U-ESR-H-00128

April 2015

Revision 0

Tank 16 – Response To NRC Comments On Closure Module

Figure 2: (Area at STA 5+00 estimated to a height of 8 inches in 2012. Attachment SRR-LWE-2012-00039)

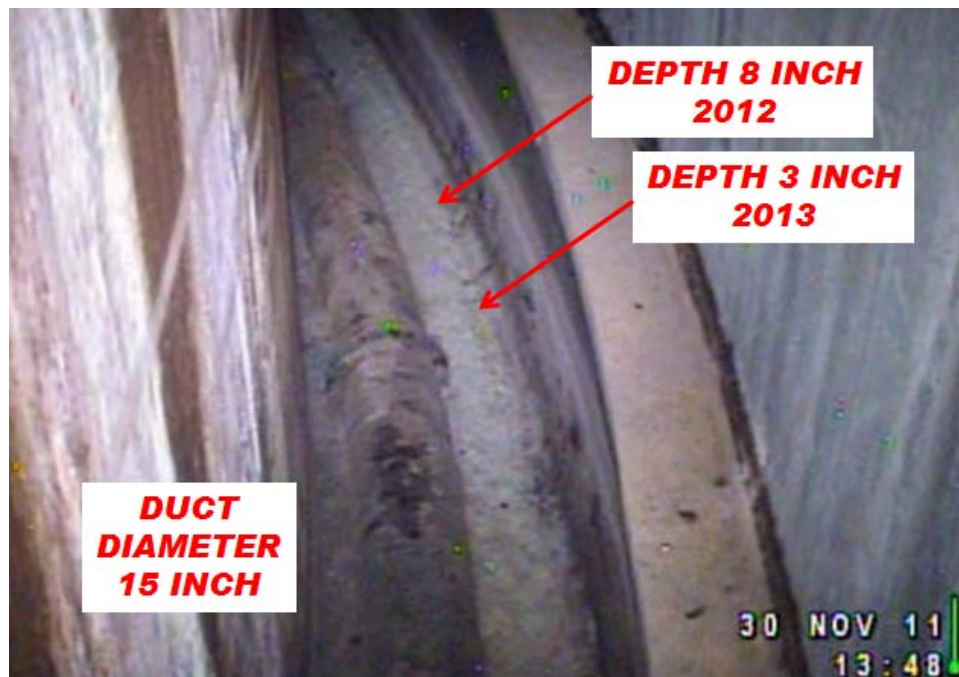
The documentation in the Closure Module could better explain why many of the visual observations from 2011-2012 were replaced with new assumptions. It seems that the photo technology would not have changed much from 2011 to 2013 to yield such different results. The differences between the use of landmarks or visual assumptions applied in SRR-LWE-2012-00039 versus U-ESR-H-00113 could be better explained. Specific examples are also provided in the following comments.

Photographs of STA 5+00 below show an area that was revised from 8 inch height in 2012 to 3 inch height in 2013. Waste height outside the duct at STA 6+00 was assigned a height of 2 inches based on interpolation of the 2 inch measured height at STA 7+00. The photograph from 2012 was used to assign a height of 8 inches to this area without close sampling measurements (Figure 2). The closest sampling data in 2012 was from 20 feet away. This value was believed to be the most realistic height based on the visual evidence at the time. The 2013 sampling effort at STA 3+50 indicated a height of 3 inches. Photo I from U-ESR-H-00113 displays the area in more detail (Figure 3). The measured sample height of 3 inches was assigned to this area because it was believed that Photo I was consistent with a height of 3 inches.

Figure 3: (Area at STA 5+00 interpolated to a height of 3 inches in 2013. Photo I U-ESR-H-00113)

Figure 6: (Area at STA 1+80 measured at 4 inches. Photo E U-ESR-H-00113)

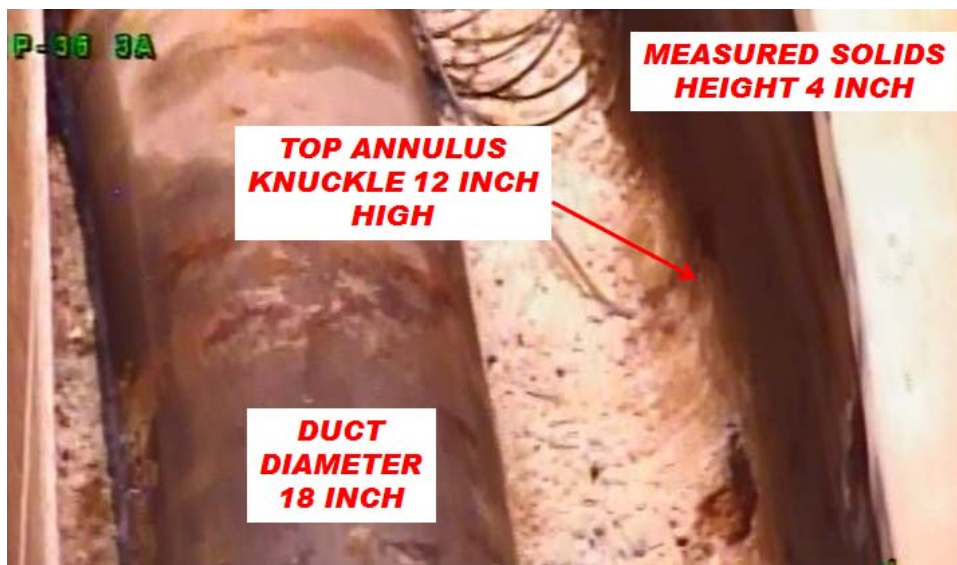
In general, the potential discrepancies between the measurements and what is observed in the photos using the landmarks could be better addressed. For example, it would be helpful if the photographs from similar locations from both 2011 and 2013 could be analyzed side by side, with the landmarks and depth assumptions clearly labeled. Information available from the measured samples could be discussed in terms of how it relates to the landmarks in each of the photos with any ambiguous or conflicting observations explained. Could DOE explain the visual evidence that supports the reduction in height for waste outside the duct near Stations 2, 3, 8, and 10?

The measured height at STA 1+80 was 4 inches in 2013. This is consistent with the measured value at South Riser STA 0+00 in 2012. A photo of the area in question is provided below (Figure 6). There are no landmarks in the area that are close to being 4 inches tall. The annulus knuckle has a 12 inch radius and the duct steel band joint is approximately 8 inches off the floor. Note that the steel band joint appears higher on the left side (Figure 7). If the steel band was configured with the joint horizontal, the level of the joint would be 10.4 inches. The solids layer in this area is below all available landmarks. There is no evidence to suggest that 4 inches is not an accurate depth for this area.

Figure 10: (Area at STA 10+00 interpolated to a height of 3 inches. Photo M U-ESR-H-00113)

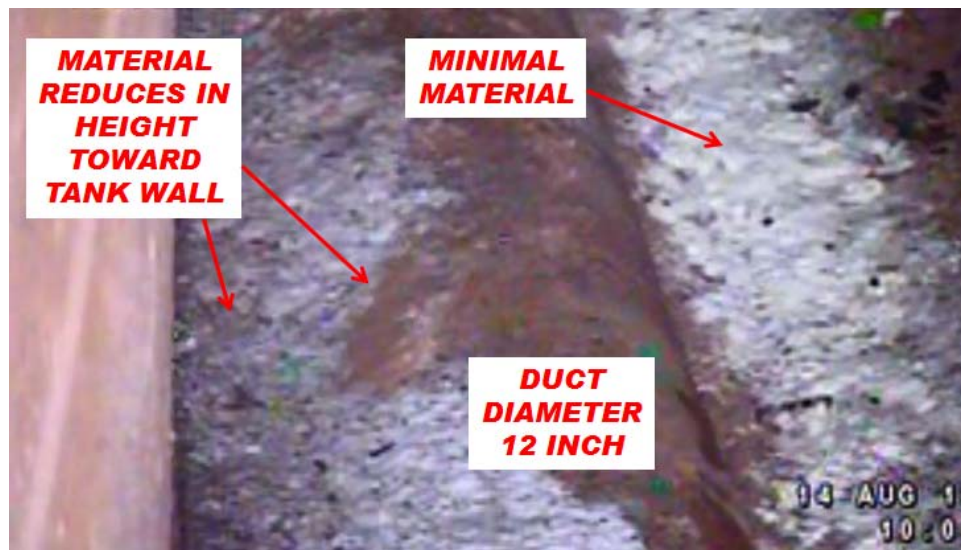
Could DOE describe the visual landmarks used in Photo M to support the height assumption at that location? Or, if instead, the height of the annulus waste near Station 10 is based on interpolation between nearby sampling locations, could DOE describe why the photographs near this Station were not used?

The interpolated height from the nearest measured heights (3 inches) was assigned for this area, and evaluation of visual evidence did not result in adjustment to the interpolated height. Visual depth perception was a factor in the decision to not adjust the interpolated height. A photo of the area is included below (Figure 10).

As stated in our methodology, an interpolation between measured sample heights was used in conjunction with visual observation to assign a height to the material in this area. STA 10+00 is an area between two measured values of 2 inches and 5.5 inches. Visual evidence suggests that the solids height did not increase between the two sample locations, therefore the value at STA 10+00 would be 5 inches or less. There is a minimal amount of material to the right side of the duct, material is coating the left side of the duct, then the material appears to decrease in height away from the duct to the left (Figure 10). Several data points were used to assign a value:

The interpolated height from the nearest measured heights (3 inches) was assigned for this area, and evaluation of visual evidence did not result in adjustment to the interpolated height. Visual depth perception was a factor in the decision to not adjust the interpolated height.

Figure 13: Portable Drill Rig

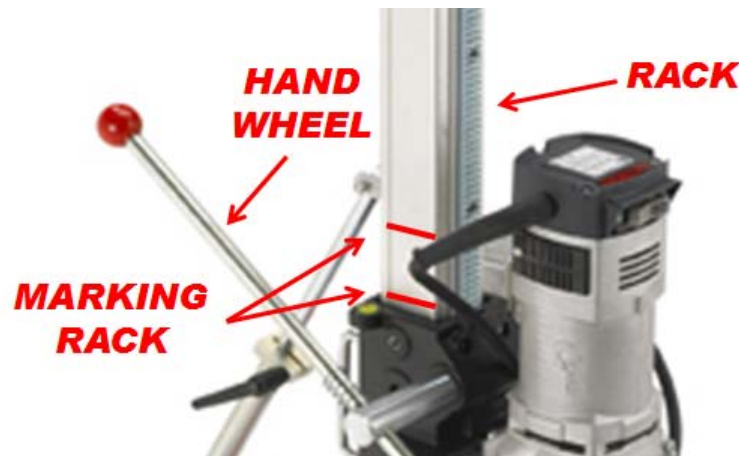
- a. Is reaching the top of the waste based on visual observation, or some other indicator?
- b. How variable are the waste height measurements due to surface roughness? If the surface of the waste is rough or variable along the radius, then there may be significant uncertainty in the height measurement in roughly the same measurement location.

The drill rig used is similar to the one pictured below (Figures 13 and 14). Vertical moment is controlled by the handwheel. The gear on the handwheel interfaces with a rack on the vertical column to hold or adjust vertical position. Marking and measuring vertical position on the column is simple and accurate. Uncertainty in this measurement would be very low.

Figure 16: Material Accumulated on Annulus Knuckle

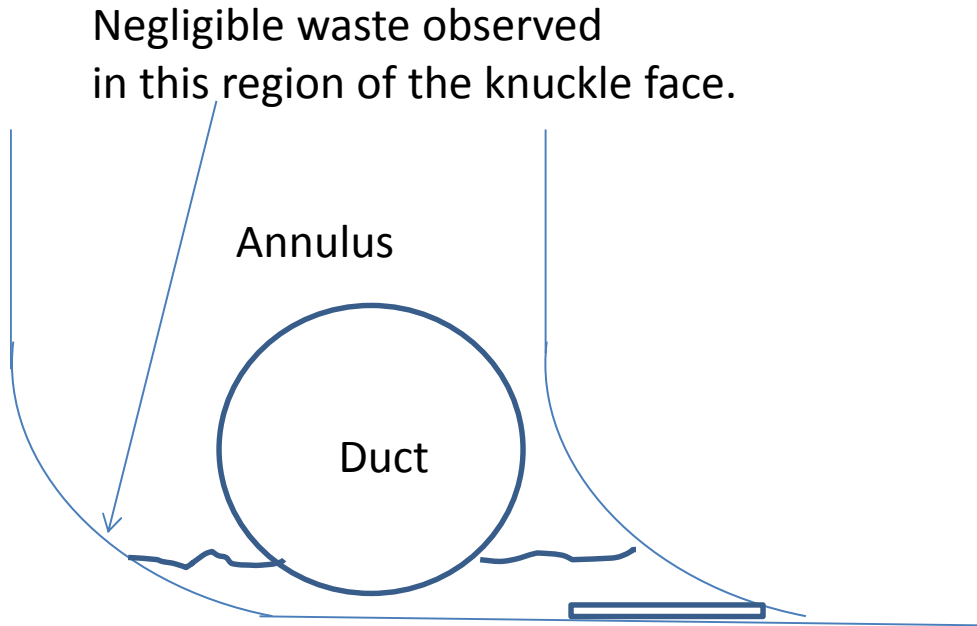
- c. How variable are the waste heights based on distance from the annulus wall or duct (i.e., does waste tend to accumulate on vertical surfaces)?
- d. It is not clear how one would determine when the top of the waste is reached in a duct where the duct itself is obstructing the view? How would one know when the auger reaches the top of waste in a duct in cases where a hole needs to be cut into the duct to sample (e.g., photograph H in SRR-LWE-2014-00151)?

Generally, solids were not observed accumulating on vertical surfaces (Figure 15). In some areas where solids height was minimal along the outside of the annulus, the level appears to conform to the curvature of the knuckle. Volumes estimated in these areas are determined according to the mapping team's judgement and experience. This was accounted for in the uncertainty values.
